January 12, 2010

TEAM UPDATE #1

Figure 8-5

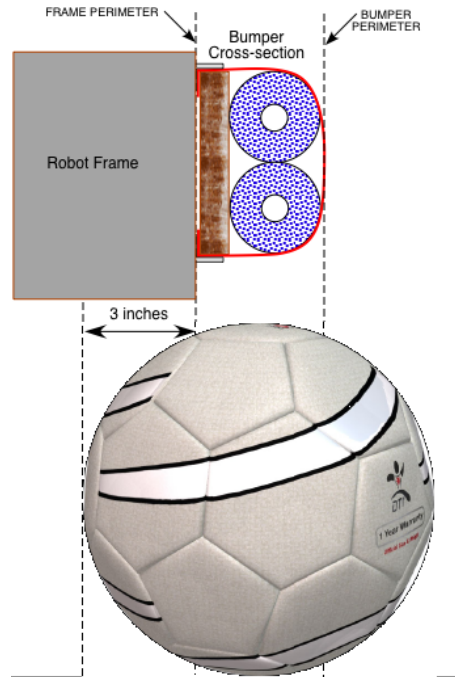
- <R19> ROBOTS must be designed so that in normal operation BALLS cannot extend more than 3 inches inside ~~the FRAME PERIMETER below the level of the BUMPER ZONE.~~
- a) the FRAME PERIMETER below the level of the BUMPER ZONE (see figure 8-5).
 - b) a MECHANISM or feature designed to deflect balls in a controlled manner that is above the level of the BUMPER ZONE.

Figure 8 - 1

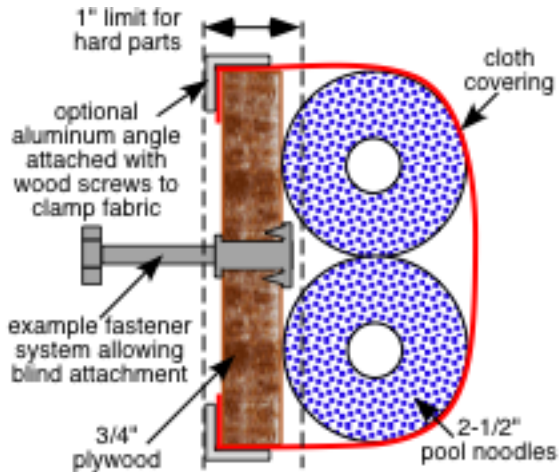
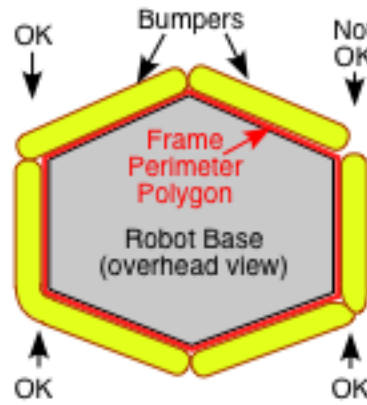
<R07> Teams are required to use BUMPERS on their ROBOTS. BUMPERS have several advantages, such as reducing damage to ROBOTS when they contact other ROBOTS or ARENA elements, and being excluded from the calculation of ROBOT weight and volume constraints specified in Rule <R10>. The BUMPER location and design have been specified so that ROBOTS will make BUMPER-to-BUMPER contact during most collisions. If implemented as intended, a ROBOT that is pushed against a vertical wall in any normal NORMAL CONFIGURATION will always have the BUMPER be the first thing to contact the wall. To achieve this, BUMPERS must be constructed as described below and illustrated in Figure 8 – 1.

- A. BUMPERS must provide complete protection of the entire FRAME PERIMETER of the ROBOT (i.e. BUMPERS must wrap entirely around the ROBOT). The BUMPERS must be located entirely within the BUMPER ZONE when the ROBOT is standing normally on a flat floor, and must remain there (i.e. the BUMPERS must not be articulated or designed to move outside of the BUMPER ZONE).

- C. BUMPERS must use a stacked pair of 2½ inch “pool noodles” as the bumper cushion material.
- D. Each BUMPER segment must be backed by a piece of ¾-inch thick by 5-inch tall piece of plywood. Each piece of BUMPER backing must be a minimum of 6 inches long. Small clearance pockets and/or access holes in the BUMPER backing are permitted, as long as they do not significantly affect the structural integrity of the BUMPER.

Figure 8 - 3

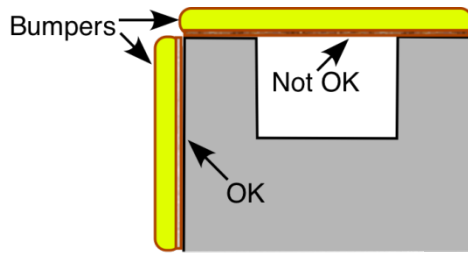
- M. The entire length of the BUMPER backing must be supported by the structure/frame of the ROBOT (i.e. the backing material must not be in “free space” between or beyond attachment points) (see Figure 8 - 3).

- N. “Hard” parts of the BUMPER (i.e. plywood backing, fastening system, and clamping angles) may extend up to a maximum of one inch beyond the FRAME PERIMETER. “Soft” parts of the BUMPERS (i.e. pool noodles and cloth covering) may extend up to 3½ inches beyond the FRAME PERIMETER.

- O. The BUMPER backing must not extend beyond the “edge” of the ROBOT. The backing of adjacent BUMPER segments must not attach to each other if the attachment would require that the joint extend into the corner (see Figure 8 – 4).
